DATE: 05.21.2014
TO: ProTrak
FROM: Bill McDow
 Transportation Planning

■ **320 CHESTNUT STREET ADDITIONS & RENOVATIONS [Plan Review# 2]**

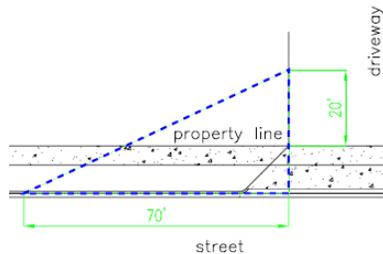
- The site plan shows parking meters and marked parking stalls on N. 4th Street which are scheduled to be removed or obstructed on the plan. Please contact Betty Gurganus at 342-2786 to coordinate the movement, storage and protection of these parking meters.
